Low/Intermediate Upgraded Servo, Spring, Pin & Retainer Clip

Sonnax Part Summary

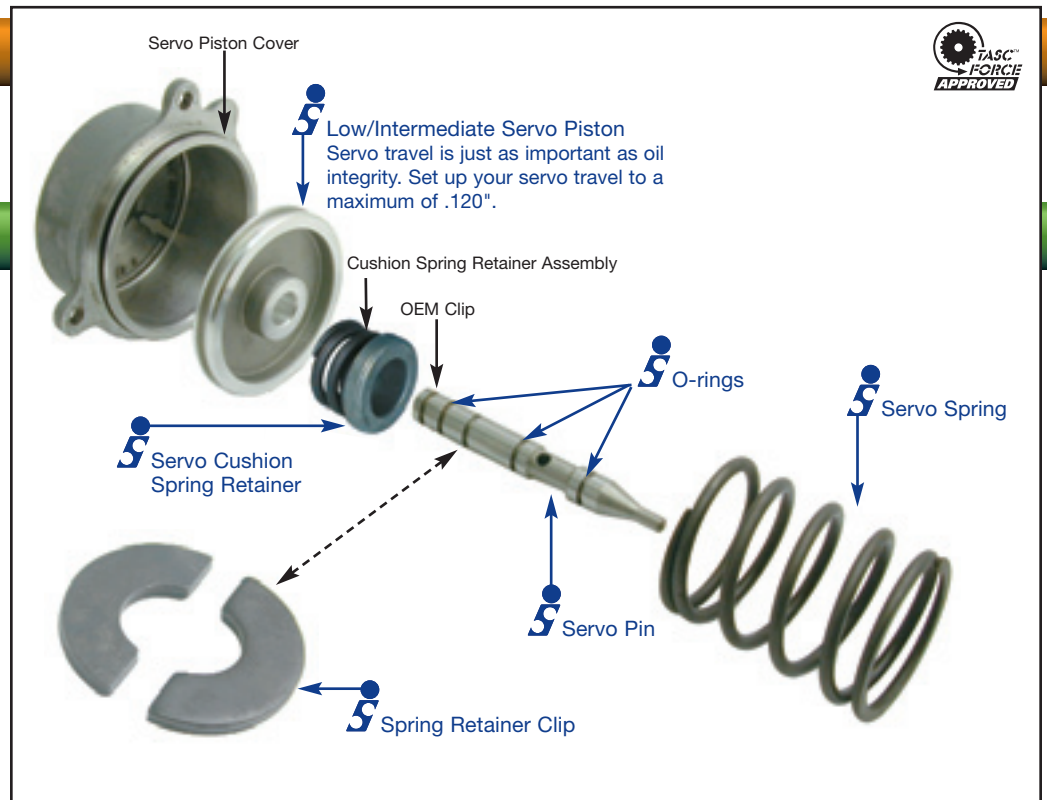
Servo pin-bore leakage, incorrect spring calibration, case bore leakage at pin, and broken parts.

- Replacement servo piston eliminates leakage at the pin bore.
- Updated spring is longer and has a spring rate approximately 12 lbs. lighter than the OEM, reducing delayed forward engagements.
- Spring eliminates downshift clunk complaints because it is stiffer than the common Chrysler replacement spring.
- Updated servo spring retainer clip is made of hardened steel for better wear resistance and has full contact on the pin groove radius, preventing breakage of the OEM clip.
- Replacement servo pin incorporates 3 o-rings for positive sealing and leakage prevention.
- Replacement servo cushion spring retainer not available from OEM.

The replacement servo corrects leakage at the pin bore, the modified spring rate provides better servo timing, and the servo pin has o-rings for positive sealing.
